Staff Report & Recommendation

Historic Preservation Board

SUBJECT: HPB25-0679, 100 Lincoln Road-The Decoplage

An application has been filed requesting a Certificate of Appropriateness for the partial demolition of the existing portecochere and associated site and groundfloor construction, and for the renovation of the portecochere together with associated site and groundfloor improvements, including variances from the maximum encroachment into the rightofway, the maximum frontage allowed along a primary elevation, and the maximum height permitted for a porte-cochere

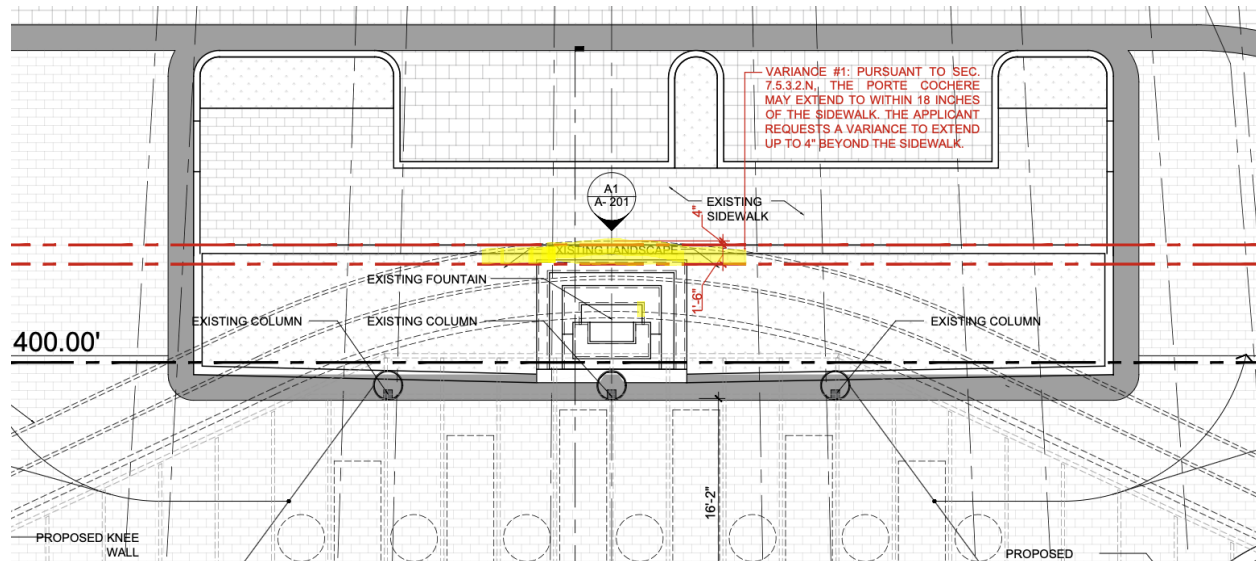
1. A variance to exceed 1'-10" of the maximum 18" setback from the sidewalk in order to construct a porte-cochere projecting 4" from the right-of-way.
2. A variance to exceed 11.6% of the maximum 30% width of the building core frontage in order to construct a porte-cochere at 41.6%.
3. A variance to exceed 6'-6" of the maximum 16' height in order to construct a porte-cochere at 22'-6".

Note: The area highlighted in yellow in the above diagram represents the extent of Variance #1, which is for only a relatively small portion of the porte-cochere.

where a sidewalk or curb is present, the structure is required to maintain a minimum setback of 18 inches from the sidewalk. The requested variance is associated with the retention of the existing structure, and the proposed serpentine stepped treatment along the edge of the porte-cochere. Due to the practical difficulties associated with the proposed renovation project and the minimal extent of the requested Variance #1, as shown in the highlighted diagram above, and its association with the retention of the existing structure, staff has no objection to the requested variance.

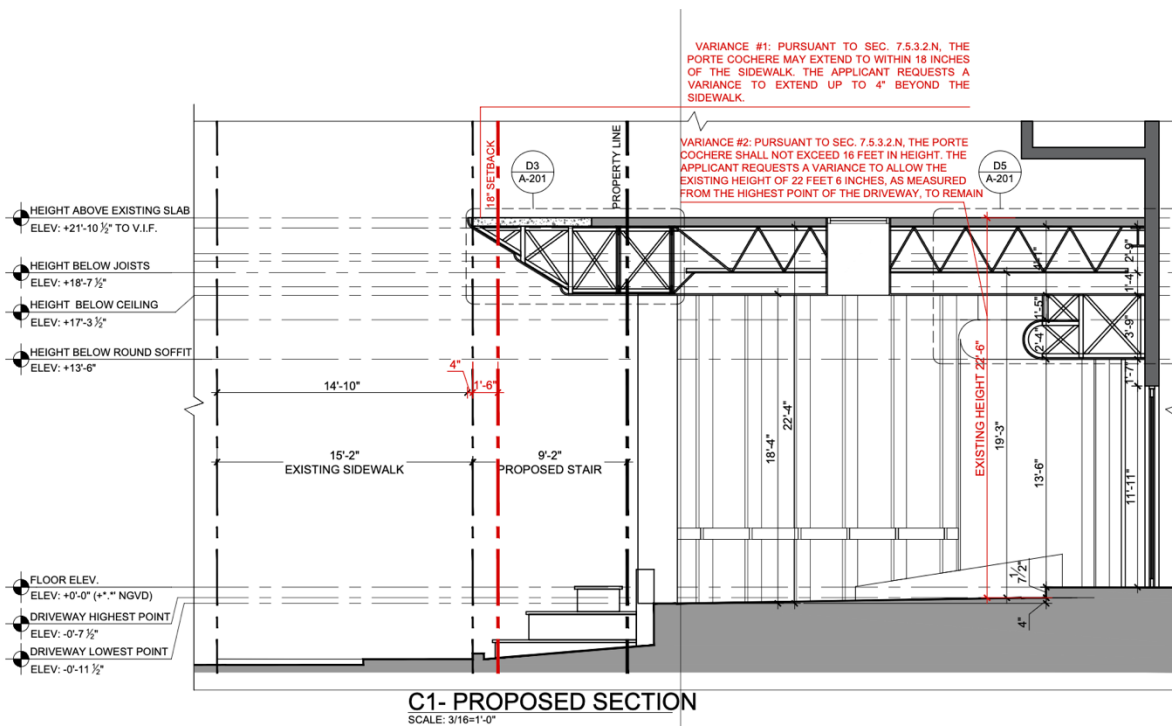
Note: The above section shows the partial extent of Variance #3 (called out by the applicant's plans as Variance #2), and its direct small extension of the existing canopy, maintaining the existing structure, and the current height of 22'-6\".

The applicant proposes to renovate and extend the existing porte-cochere to match its current nonconforming height of 22'-6", exceeding the 16'-0" maximum. The request does not introduce additional vertical massing beyond what currently exists; rather, it allows for the horizontal extension of an existing nonconforming condition, as illustrated in the section diagram above.

The elevation changes between the driveway, ramp, and finished floor require vertical clearance to safely accommodate vehicular access and pedestrian entry. Enforcement of the 16-foot limit would result in clearances incompatible with existing grading conditions and would restrict access for a range of vehicles, including service and emergency vehicles. The proposed height is the minimum necessary to address these conditions while maintaining safe and functional operations beneath the structure. Accordingly, staff is supportive of Variance #3.

- b. The porte-cochere height shall not exceed 22'-6" as measured from the highest point of the driveway, consistent with the existing nonconforming structure. No increase in height above the existing structure shall be permitted.
